Product Change Notification

PCN 2019-10-2061-1

SMD and THR PCB terminal blocks 2061 series

2. Dimensional changes

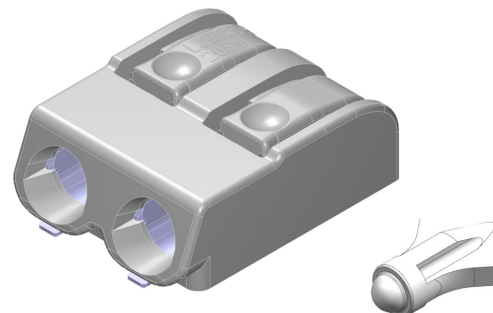
In order to optimize the operation of 2061 series, the shape of push buttons and the operating tools will be changed. With the optimized geometry the tool is guided more accurately to the intended spot of operation thus ensuring an easier handling.

Current Version

New Version

The overall dimensions and technical data of the new versions are identical to the current versions. They can be used in combination with the existing connecting links. UL and EN/IEC certification data are identical and certifications remain valid.
